Notice of Allowability

10/768,530

RICHARDS ET AL.

Figure 1.

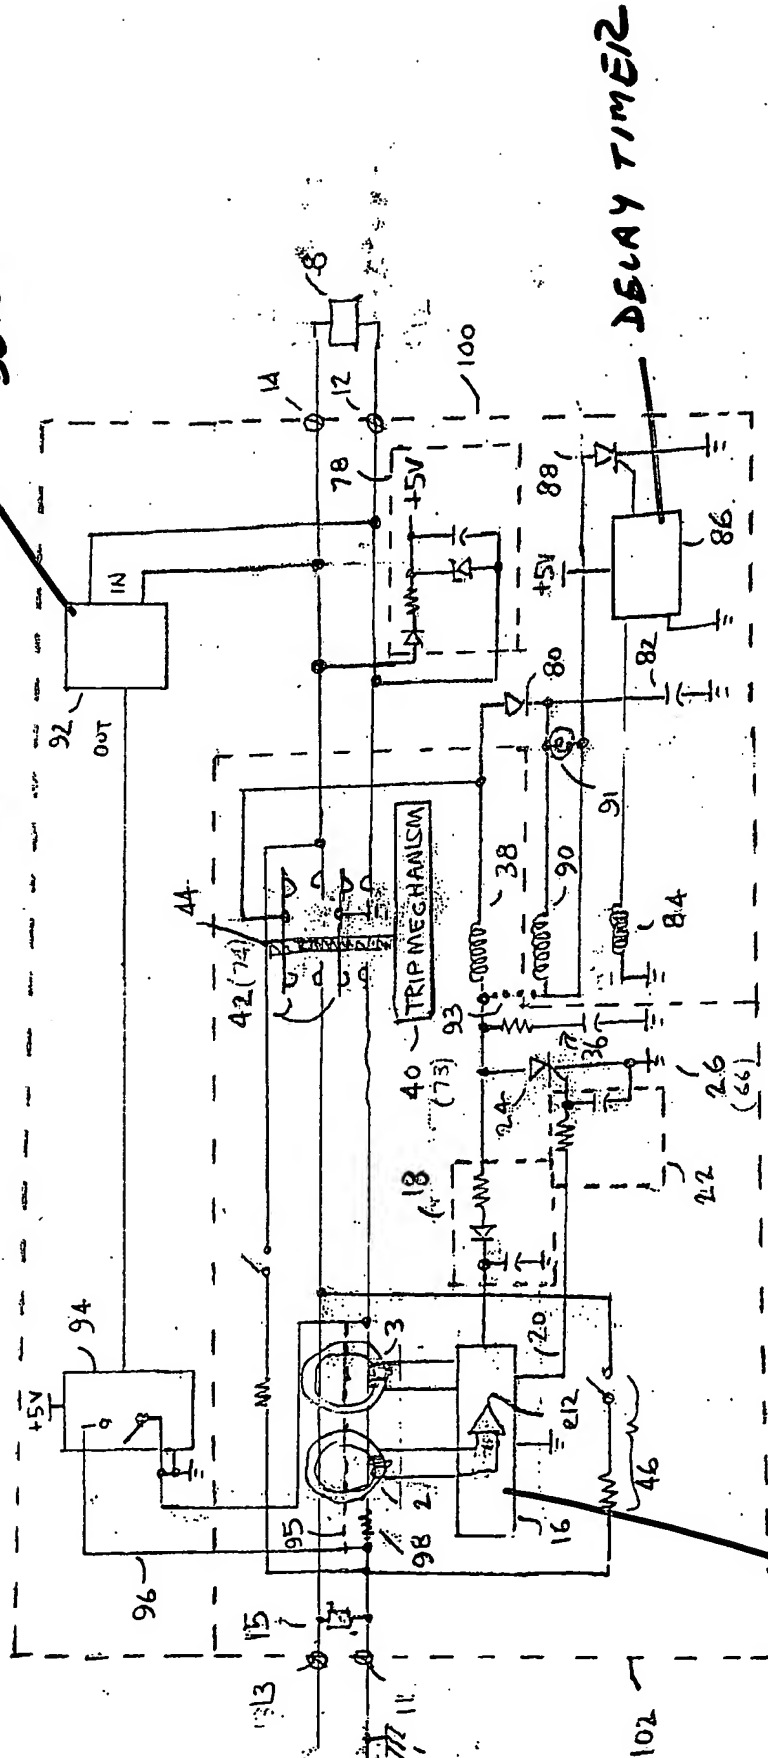
In the drawing, Figure 1 (see attached drawing corrections),

- added descriptive label --POLARITY DETECTOR--for box 92
- added descriptive label -- GROUND FAULT DETECTOR -- for box 16
- added descriptive label -- DELAY TIMER -- for box 86

POLARITY
DETECTOR

DELAY TIMER

GROUND FAULT
DETECTOR
